Regular Meeting of the Planning Commission

ITEM DESCRIPTION: ZONING CASE 18-07: SITE PLAN AND VARIANCE FOR

SUBJECT: MCCU Site Plan Review

I have reviewed the preliminary plans for the MCCU site including site plans, stormwater management report, prepared by Northland Consulting and dated 6/22/18 received 6/26/18 by email

STORM WATER POLLUTION sheet PREVENTION PLAN

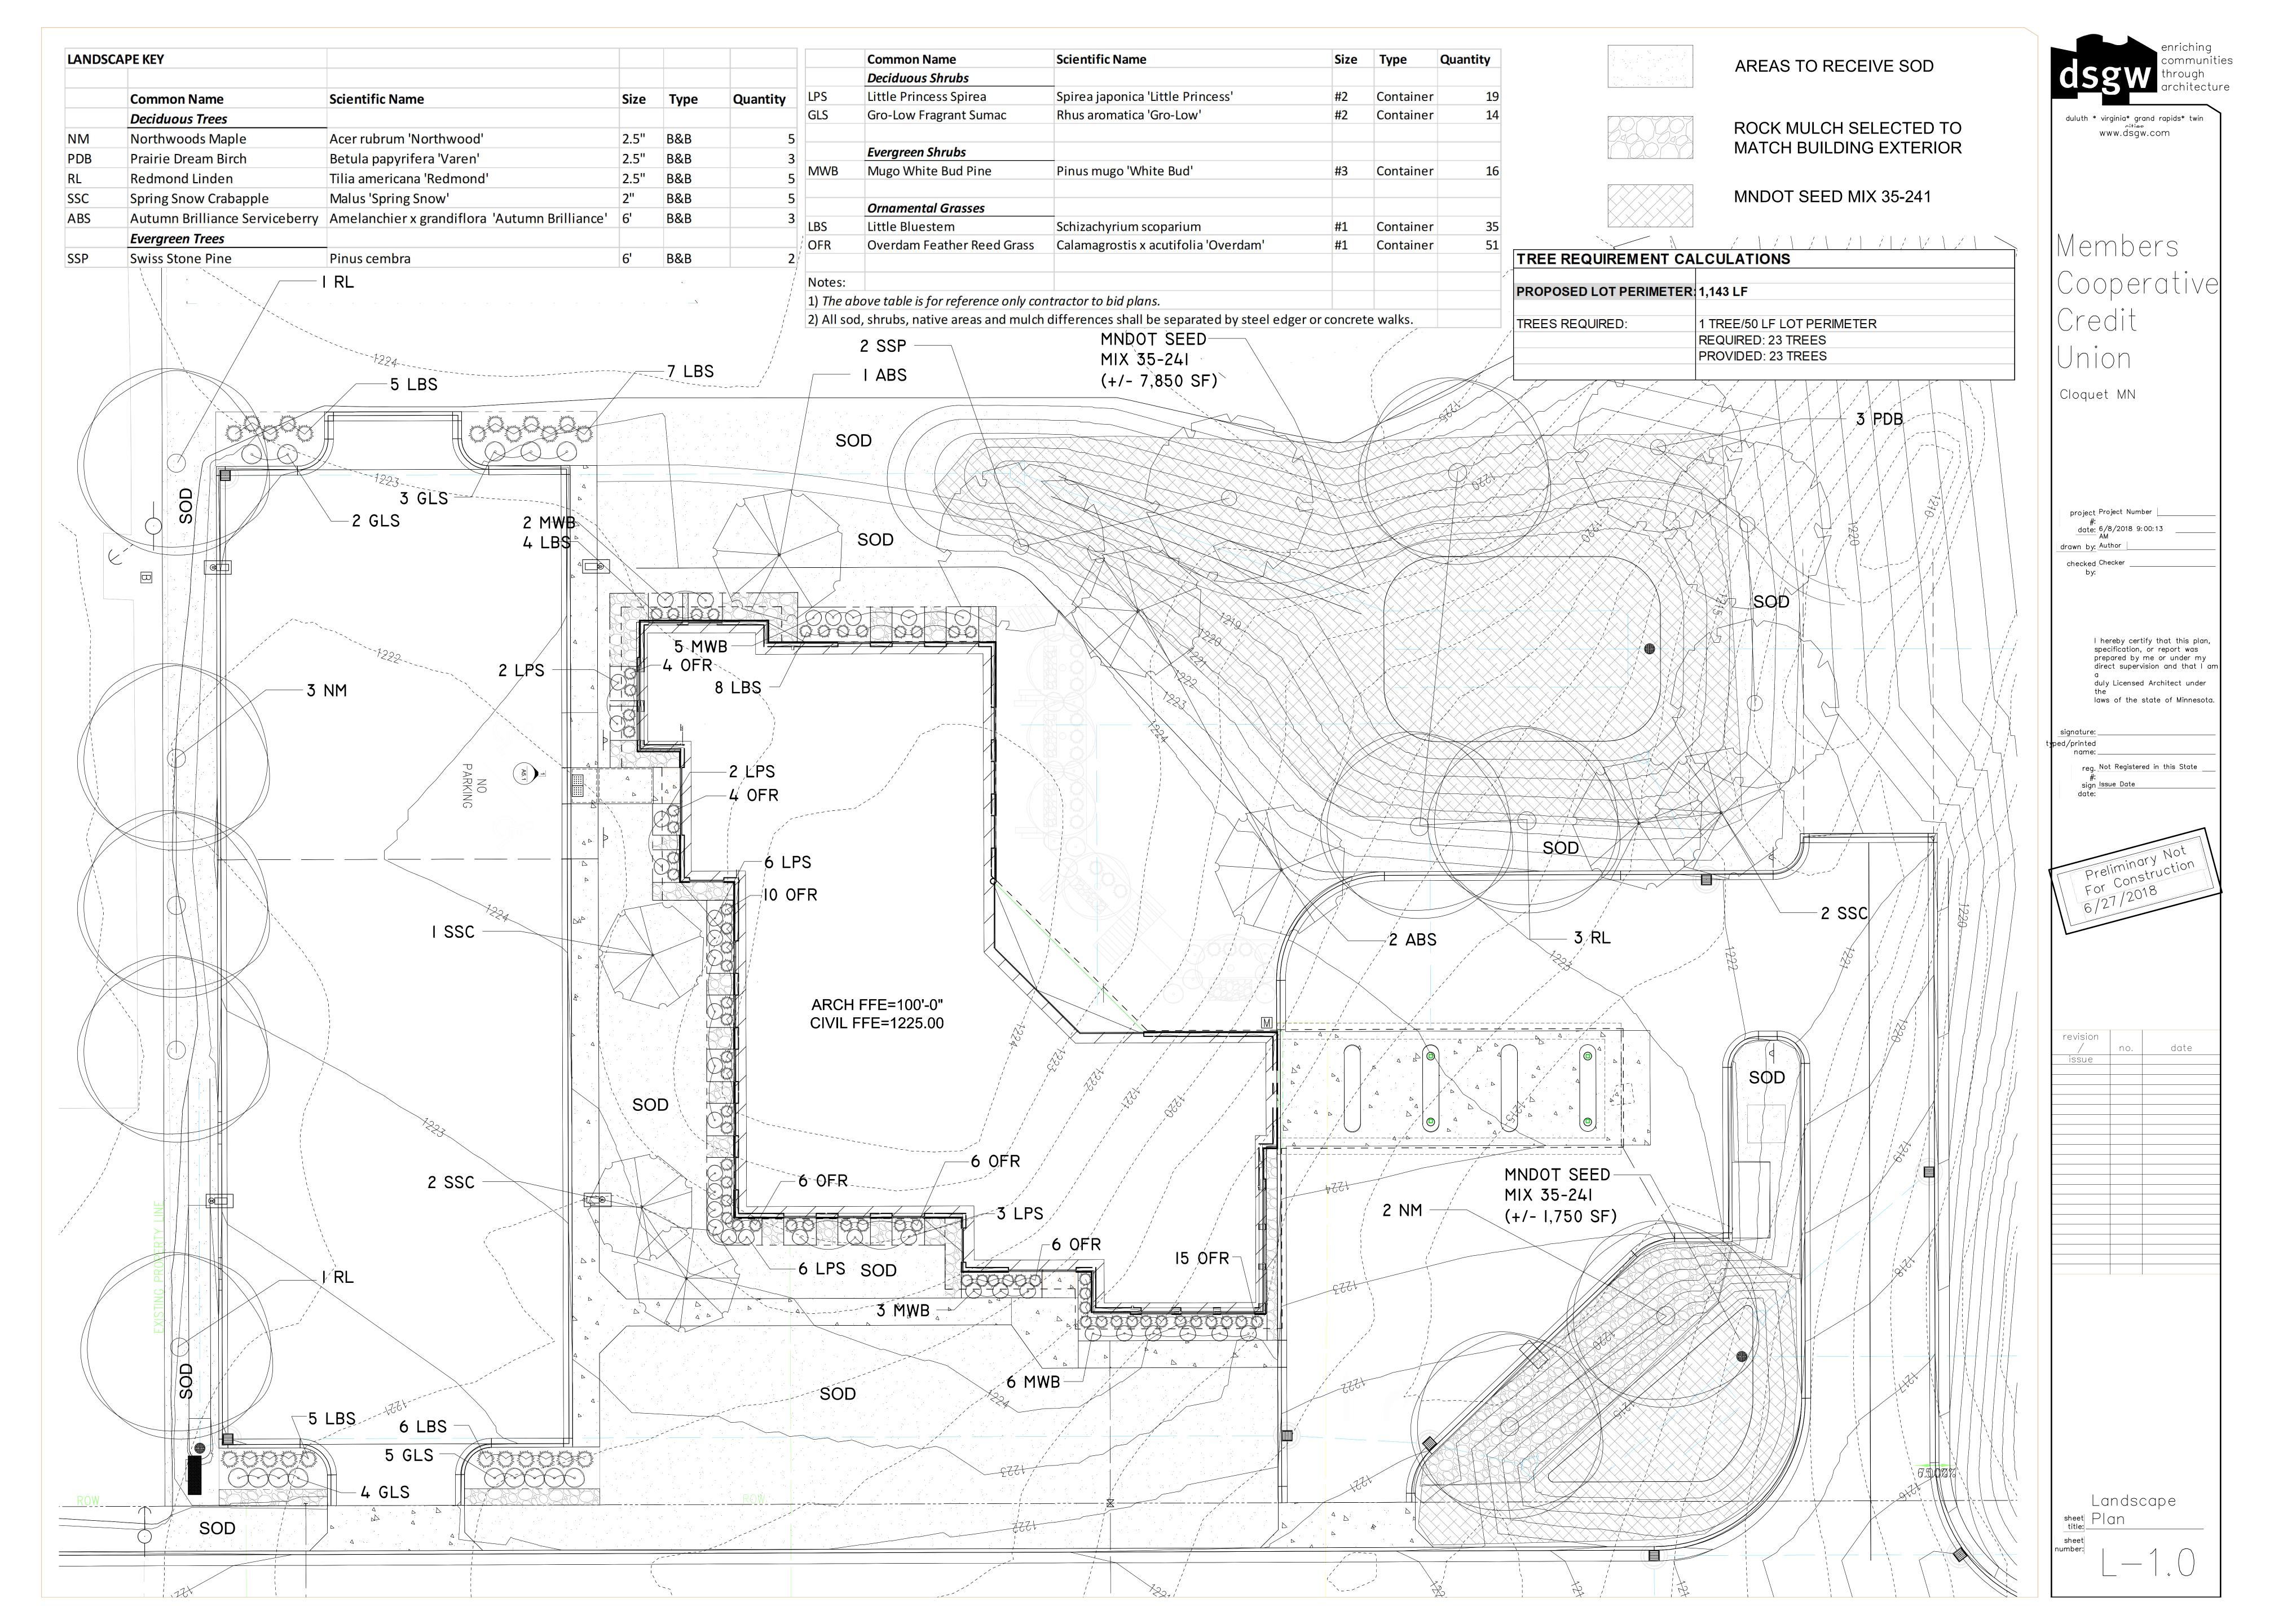
Sheet C 7.0
 - 32. There is a trout stream just south of this site and this is where the drainage is routed ultimately from the site. The SWPPP designer must identify if this requires this SWPPP to meet requirements of special waters.

- 33. The SWPPP plan shows different shading and symbols but does not include a legend
 - 34. The SWPPP should include staging to require utility connections to be made to the existing sewer, water and storm sewer extended past station 2+75 and street restoration including curbing and bituminous base pavement put back in place before proceeding with the rest of the site work.

- 35. SWPPP implementation contacts should include City of Cloquet / John Anderson (218)879-6758
 - 36. Data missing in clouded areas on the plan.
 - 37. Consider installing temporary berms to divert stormwater flow into storm water ponds being used as temporary sedimentation ponds.

- 38. Show floating outlets that draw water of the top of the temporary basin as required by the NPDES permit.
 - 39. Construction exit should be shown to the north of the last driveway to the strip mall
